Subject: Supplemental Data Response, Set 6
Hidden Hills Solar Electric Generating System (11-AFC-2)

Supplemental Data Response Set 6

Hidden Hills
Solar Electric Generating System
(11-AFC-2)

APPLICANT'S RESPONSE TO DATA REQUEST #159

Figure 1

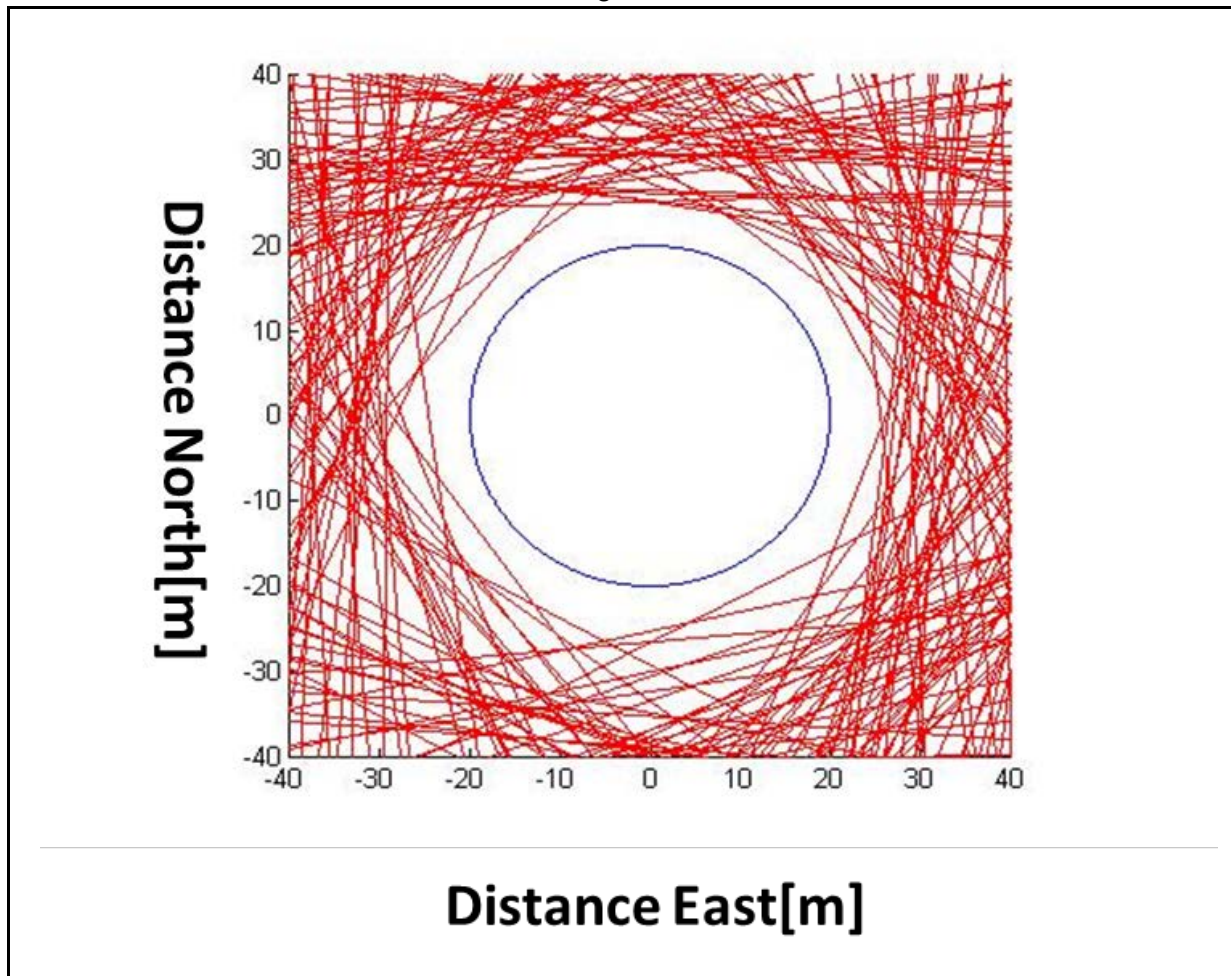
Heliostats in the standby mode are modeled to be aiming to a torus-like or halo shape which surrounds the receiver, as illustrated in Figure 1 below which shows looking from above the SRSG, the solar ray paths of the center of heliostat beams around the SRSG (blue circle).

Figure 3: Plan View of Flux at Full load with 0% standby over RMS 1 Solar Field

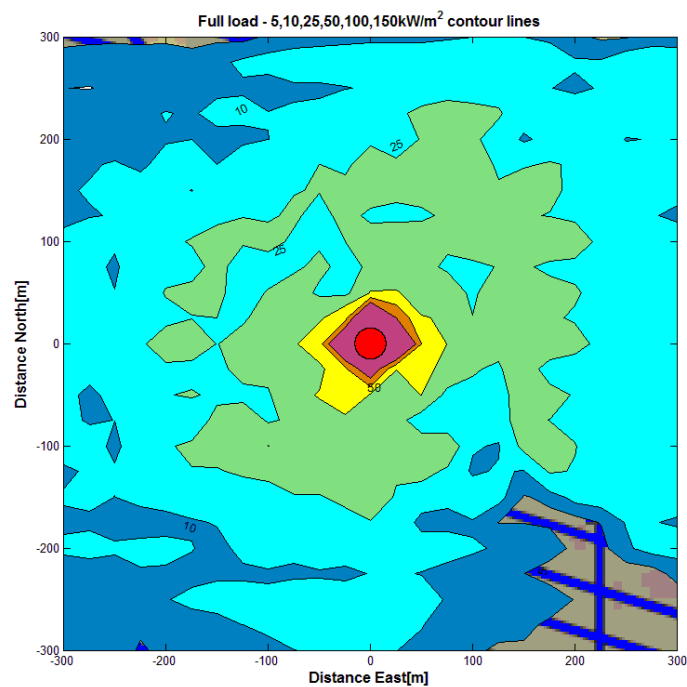
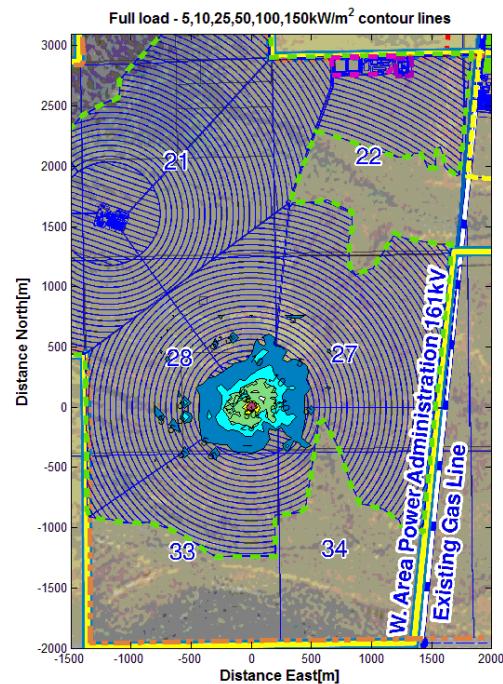
- f. The boundaries of the analysis should identify the location of the microphyll woodland habitat that would be retained within the mirror field in Section 22.

Part f. Complied, See Figure 3

The total air space volume with a flux maximal quantifier of greater than 5kW/m^2 is approximately 0.88% (Figure 3). The diametrical span of this flux level is approximately 400m from the tower center and the volume is approx. $23 \times 10^6 \text{ m}^3$ while the total air volume over the solar field is approximately $2.6 \times 10^9 \text{ m}^3$ (one unit). As shown in the images above, the volume occupied by flux greater than 10kW/m^2 and 50kW/m^2 is much smaller and is less than 0.4% and 0.04% from the total air volume of the solar field respectively.
